NUCLEAR ENERGY INSTITUTE

August 16, 2001

**Response to NRC's RAI Letter, Dated May 18, 2001,  
Regarding High Burnup Fuel Characteristics**

**August 10, 2001**

Figure 1 - Critical Strain Energy Density

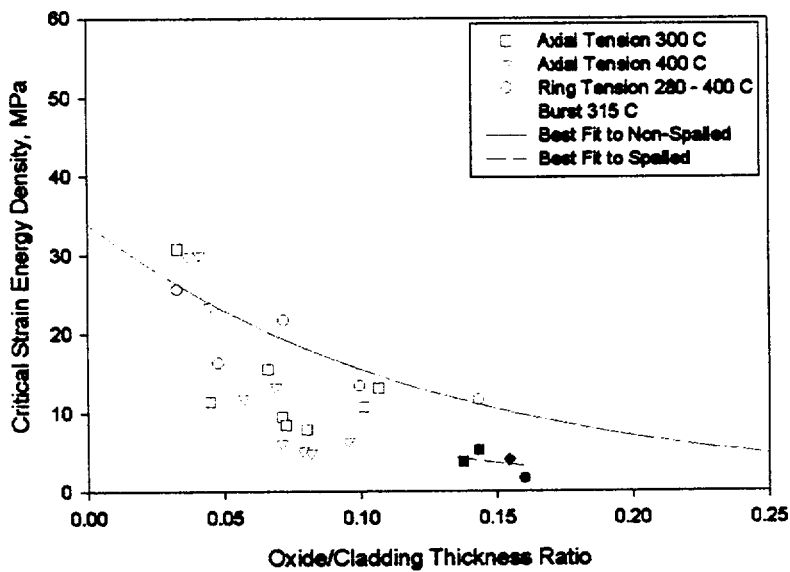
***C-2. The submittal considers an approach relating a critical strain energy density (CSED) value for any material to the corresponding fracture toughness for the material. Essentially, the CSED is equated to the integrated stress-strain area in a mechanical strength test. The CSED values and associated estimated fracture toughness are then compared with fracture/rupture data. In the report, it is shown that the behavior of CSED as a function of cladding oxide thickness is different for the different loading (stress) conditions. However, in general, creep tests, tensile tests, and impact load-type (fracture toughness) tests involve different stress and temperature states and different fracture mechanisms. Show that the set of CSED data presented in the report is applicable for the range of stress and temperatures that are typical of dry cask storage. Although the potential complications are recognized in the paper, provide a detailed and complete CSED analysis relevant to Zircaloy clad fuel, including confirmation and verification of analysis with data from high-burnup fuel.***

The sentence, "In the report, it is shown that the behavior of CSED as a function of cladding oxide thickness is different for the different loading (stress) conditions." must be referring to Figure 3-4 in EPRI Report 1001207, which is reproduced below as Figure 1 for easy reference.

The critical strain energy density (CSED) is constructed from mechanical property tests using the integral,  $CSED = \int \sigma_{ij} d\epsilon_{ij}$ , where  $\sigma_{ij}$  and  $\epsilon_{ij}$  are the stresses and strains measured in the test. Repeated indices imply summation. As the integral implies, the definition of CSED admits uniaxial as well as multiaxial tests, which defines CSED as the total mechanical energy delivered to the material by the loading that contributed to failure. CSED has the units of energy per unit volume, i.e., MJ/m<sup>3</sup>, or MPa, and is by definition a normalized quantity. However, it is dependent on the environment and material conditions, such as temperature, hydrogen concentration, flaws and defects, etc. These factors, plus the usual experimental scatter contributed to the spread in the data in Figure 1.

Figure 1 – Crack Stability Profile

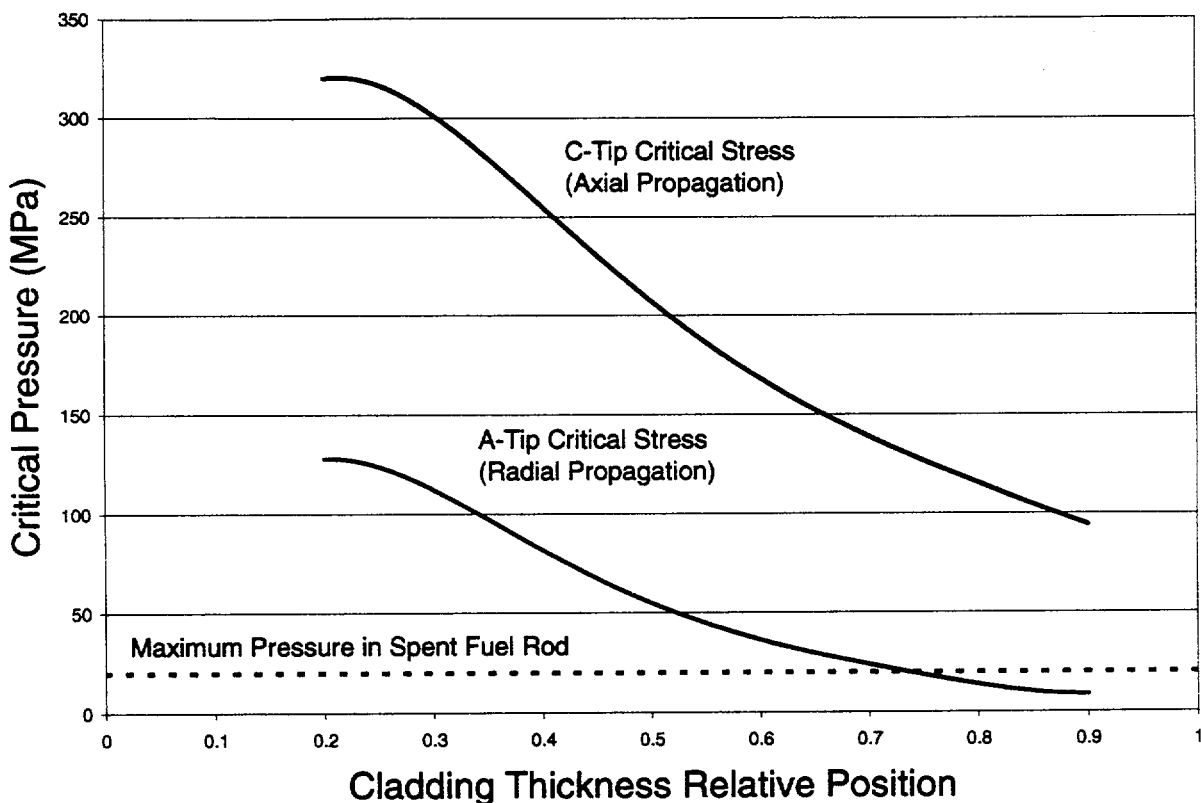
***B-7. The last paragraph on page 5-1 states that, "This demonstrates that in the event of fracture, the crack will propagate slowly in a self-similar manner.....before it can extend axially in a burst mode. The above calculations are valid for all cladding conditions regardless of oxide thickness or the state of the oxide, coherent or spalled." Justify that the velocity of the pressure wave is greater than the velocity of the crack. Additionally, since there are limited data applicable to high burnup fuel under dry cask storage conditions, describe the uncertainties associated with both the selection of the pin-hole-equivalent mode of failure and the fracture toughness data that were used to perform the calculations.***

The NRC staff review questioned the validity of the analysis, asking for information on depressurization rate versus crack propagation rate following initiation. The implication from the question is that the NRC staff:

The complete range of calculations for the c-tip and a-tip of the postulated flaw, as a function of the dimensionless flaw depth,  $a/t$ , is shown in Figure 1. Note that the flaw depth must increase to  $a/t = 0.75$  before internal pressure can cause flaw initiation at the a-tip. For that same flaw, the internal pressure necessary to cause the flaw to extend axially is 125 MPa, 6 times the maximum internal pressure.

The critical flaw depth at which internal pressure can cause radial flaw extension is about  $a/t = 0.75$ , or a flaw depth of about 0.54 mm. At such a flaw depth, unstable flaw extension through the remainder of the cladding thickness will be caused by an internal pressure of 21 MPa. For that same flaw depth, the circumferential stress is too low, by a factor of 6, to cause axial flaw extension. However, if such a stress were possible, the flaw extension would be stable, as the results of crack growth resistance in the elastic-plastic region.

Figure 1. 350°C / 386 MPa FALCON Creep Rupture Validation by ABAQUS

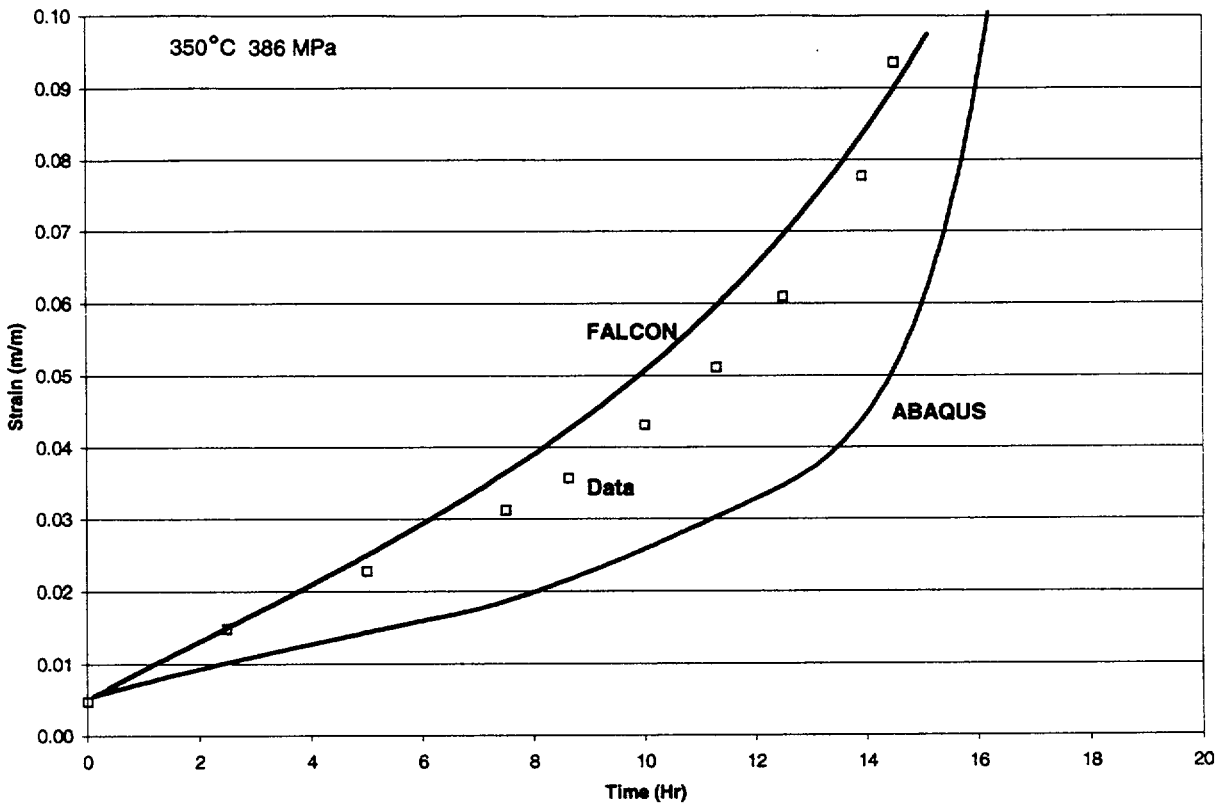
*D-1. The FALCON code was used to predict the creep behavior of Zircaloy cladding (slide 11). In those slides, good prediction was indicated for creep to rupture for only two creep specimens that appear to be from unirradiated cladding. Provide additional justification of the ability of the FALCON code to predict the creep behavior of a wide range of cladding materials and condition.*

Creep rupture analyses produced by the FALCON code, presented during the NEI/NRC Meeting on April 18, 2001, were questioned by PNNL staff regarding the ability of computer codes to predict creep rupture. This is not an unjustified reaction; the material modeling and computational problems involved in such highly non-linear behavior are quite complex, not to mention the demands on the analyst's skills and experience. Since the FALCON code is used as the computational tool for the development of dry storage creep methodology, much would depend on gaining technical confidence of the NRC and PNNL staff in the capability of the code. To this end, we have undertaken an effort to compare the FALCON code to a general-purpose finite element code that is well known for its non-linear capabilities, namely, ABAQUS [1].

Figure 1 shows the ABAQUS and FALCON results for the EDF/CEA 350°C-386MPa closed tube creep rupture test. The FALCON and ABAQUS predictions are plotted against the measured creep rupture data. Both the FALCON and ABAQUS predictions are seen to be in good agreement with the measured data. The ABAQUS prediction does not agree as well with the data, except for the prediction of the time to rupture (~15 hours).
